WOODMEN HILLS REC CENTER
9205 MERIDIAN RANCH ROAD
EL PASO COUNTY, COLORADO

JOB NUMBER	953-20
REVISIONS	
ORIGINAL DATE	10-1-20
DRAWN BY	JM
DESCRIPTION	LANDSCAPE PLAN
SHEET NO.	L1.1

Landscape Plan drawings v_1.pdf Markup Summary

OVERALL LANDSCAPE PLAN

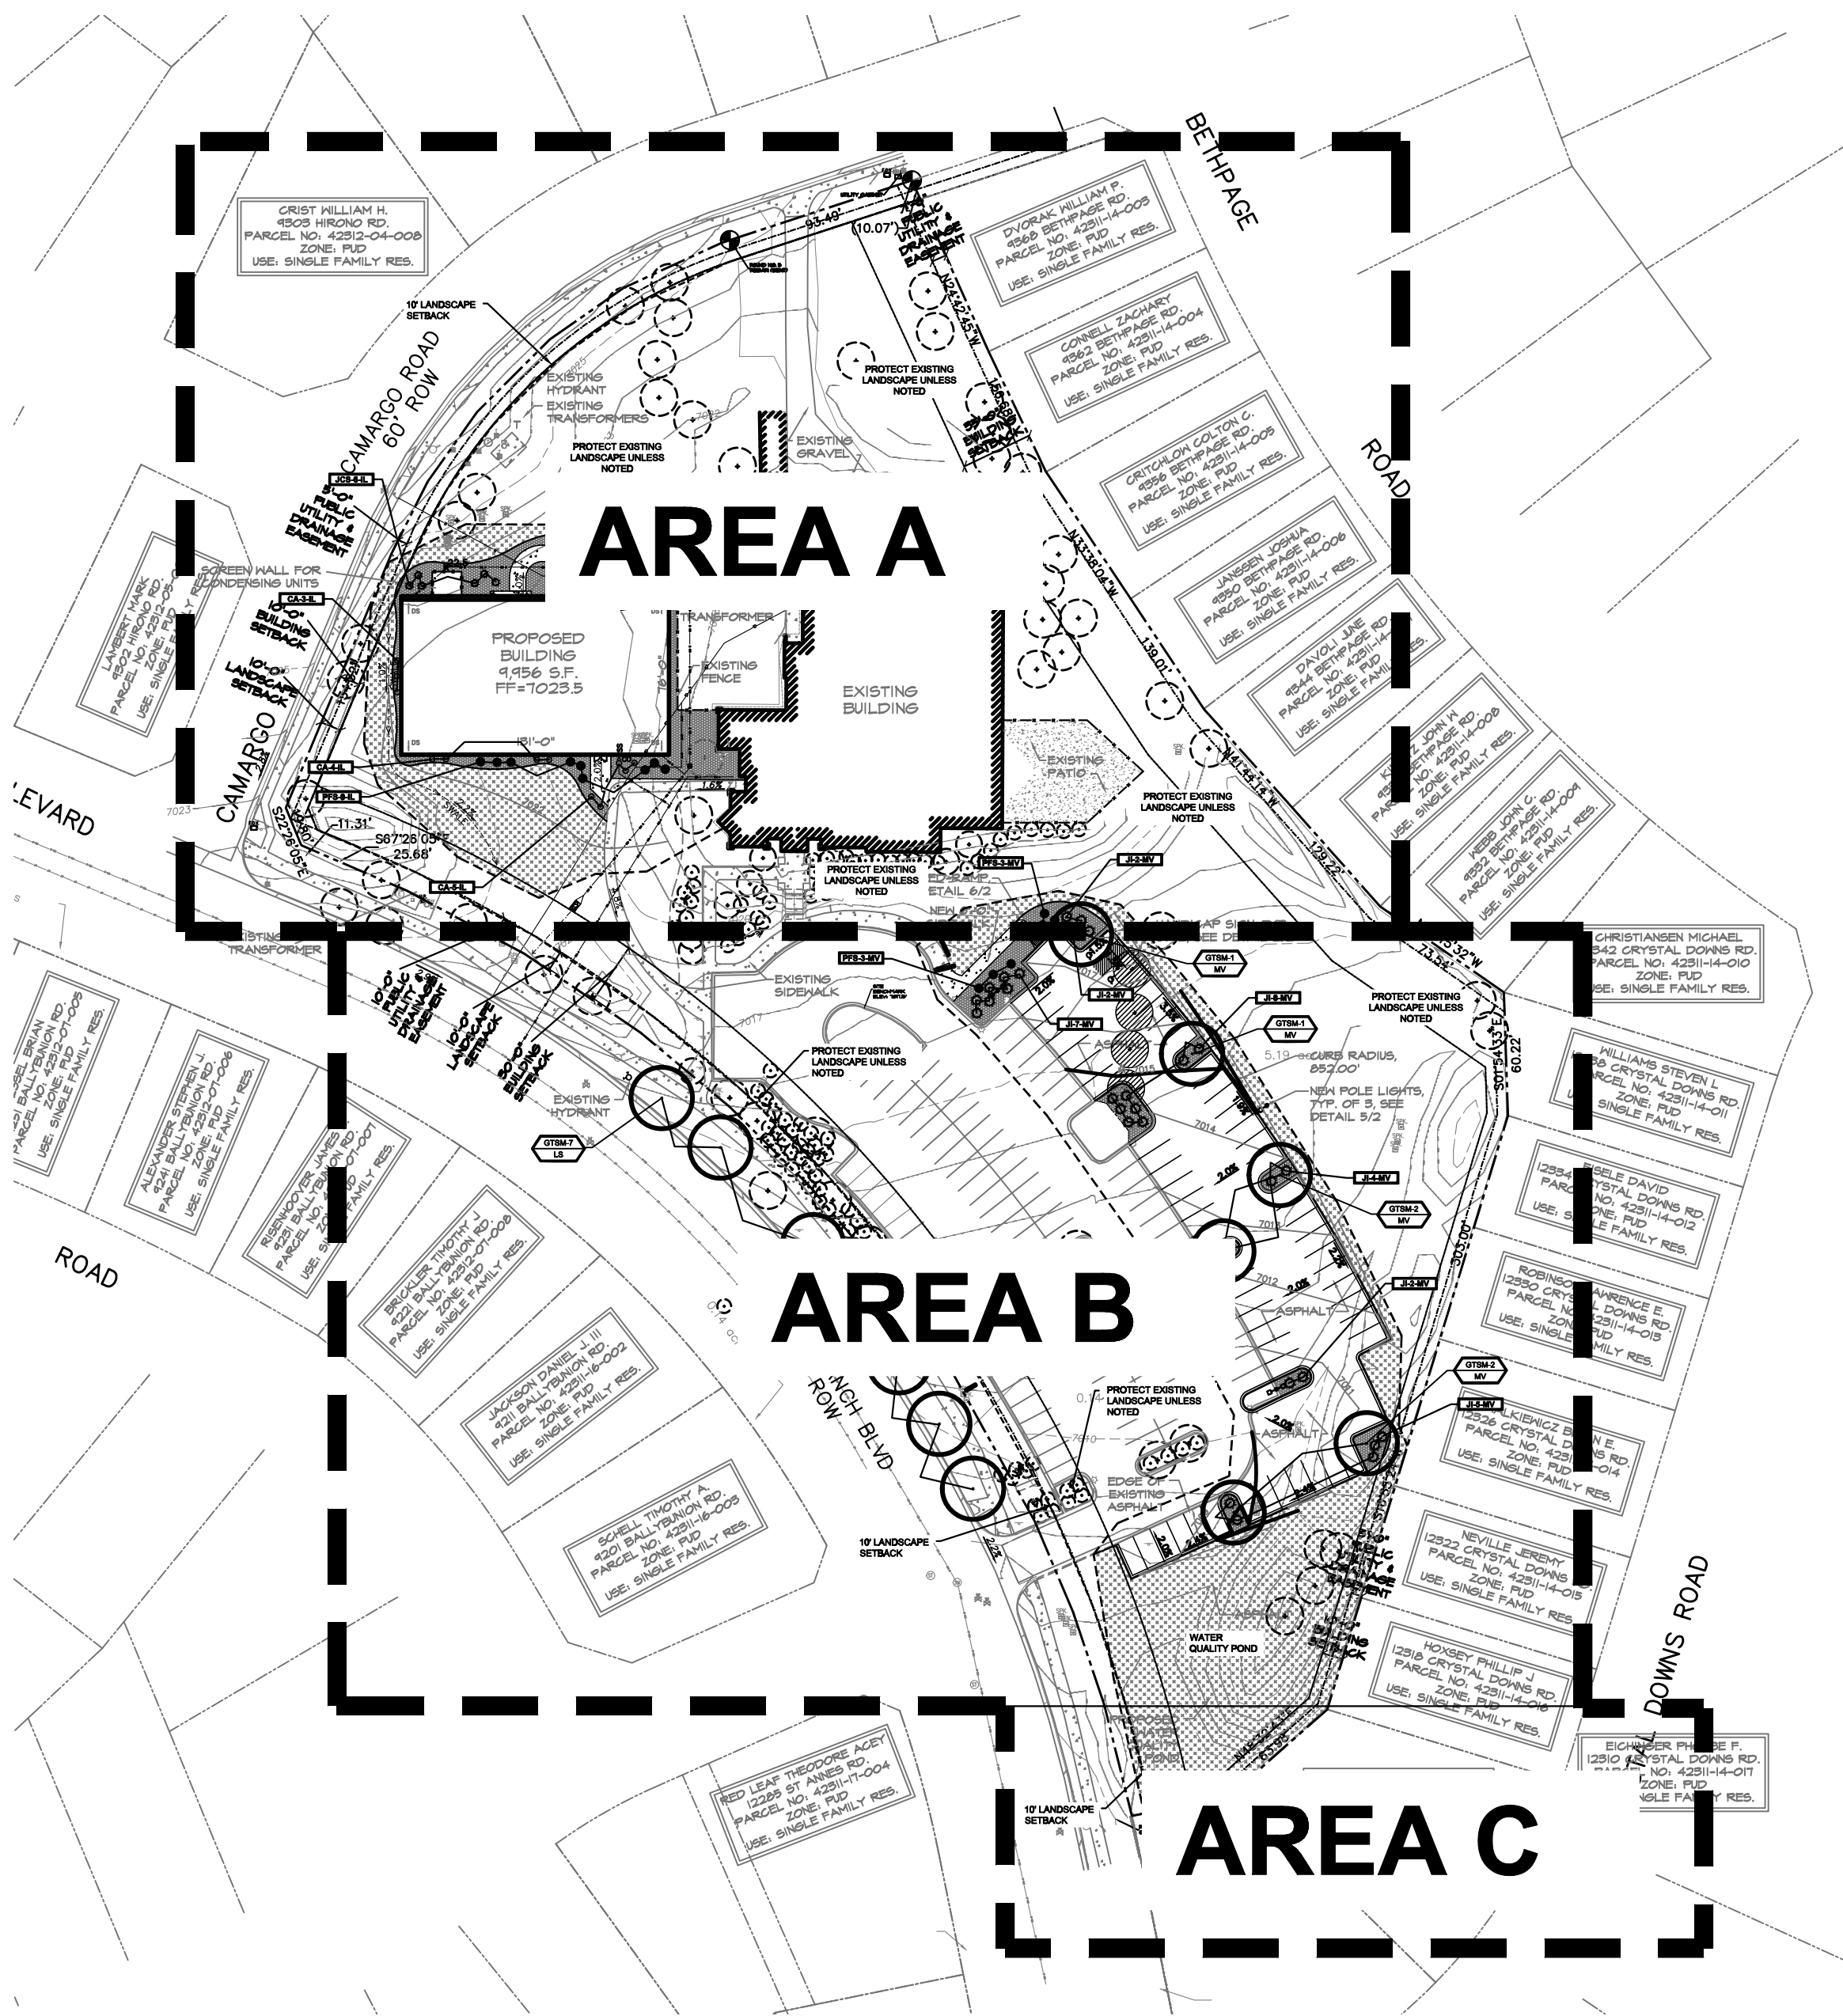
Please refer to Land Development Code Chapter 6 - Table 6-1 for roadway landscaping requirements by roadway classification. Note that the Camargo is Urban Local and Meridian Ranch Blvd is an Urban Non-Residential Collector

Please refer to Land Development Code Chapter 6 - Table 6-1 for roadway landscaping requirements by roadway classification. Note that the Camargo is Urban Local and Meridian Ranch Blvd is an Urban Non-Residential Collector

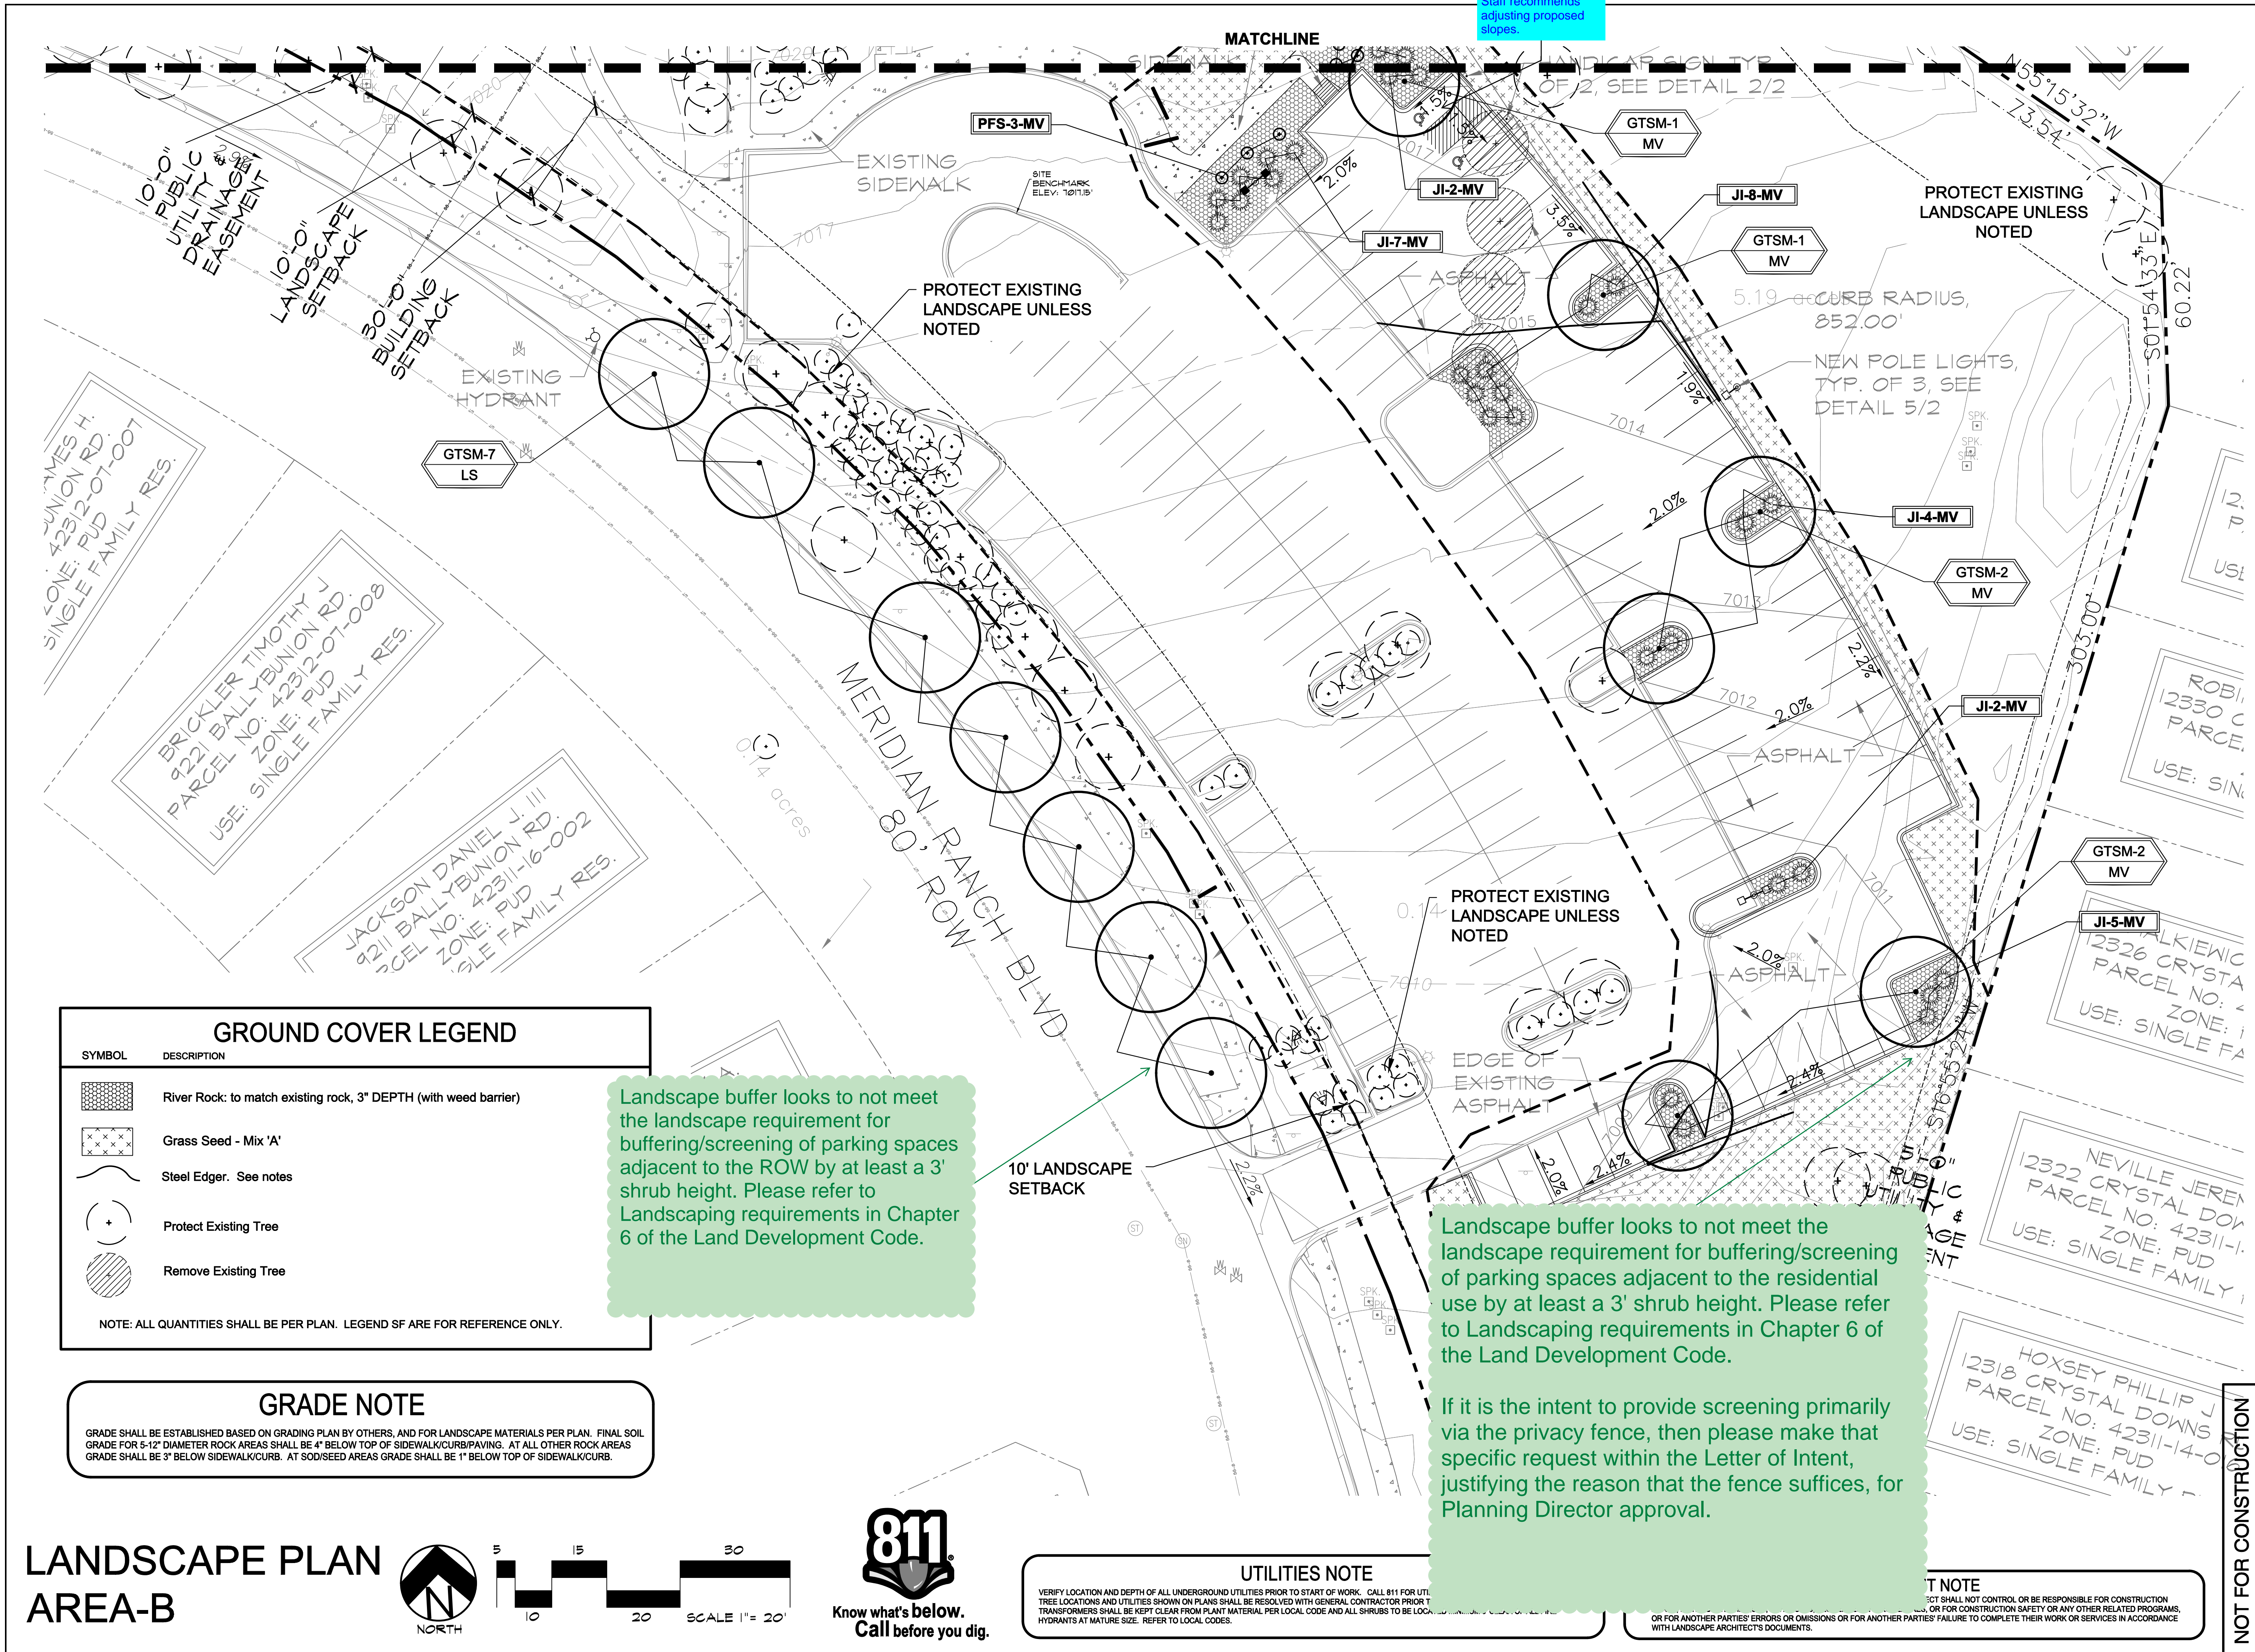
exceed 2% max and may not comply with ADA regulations. Staff recommends adjusting proposed slopes.

Landscape buffer looks to not meet the landscape requirement for buffering/screening of parking spaces adjacent to the residential use by at least a 3' shrub height. Please refer to Landscaping requirements in Chapter 6 of the Land Development Code.

If it is the intent to provide screening primarily via the privacy fence, then please make that specific request within the Letter of Intent, justifying the reason that the fence suffices, for Planning Director approval.

Landscape buffer looks to not meet the landscape requirement for buffering/screening of parking spaces adjacent to the ROW by at least a 3' shrub height. Please refer to Landscaping requirements in Chapter 6 of the Land Development Code.

Slope appears to exceed 2% max and may not comply with ADA regulations. Staff recommends adjusting proposed slopes.
